PROPOSED RESIDENTIAL SUBDIVISION (STAGES 1 AND 2)

87 - 93 KOPLICK ROAD, PARK RIDGE
FOR 'KOPLICK DEVELOPMENTS PTY LTD'

LOGAN CITY COUNCIL
APPROVED PLAN OF DEVELOPMENT
This is the approved plan of development for Development Application
OW/52/2020

SECTION A
SCALE 1:100 (A1)
SCALE 1:200 (A3)

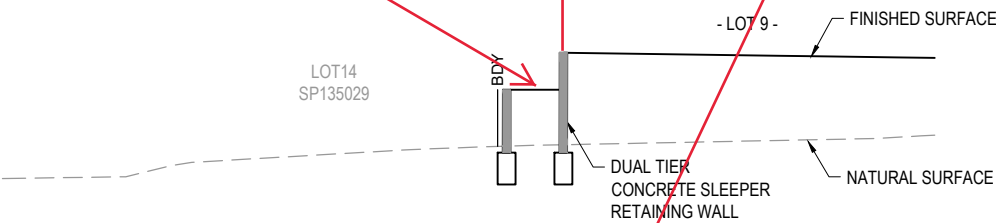
1.8m fence with a lockable gate to lots 6 to 17 enter to the landscaped area for maintenance to be provided prior to plan sealing.

Landscaped screening to be provided
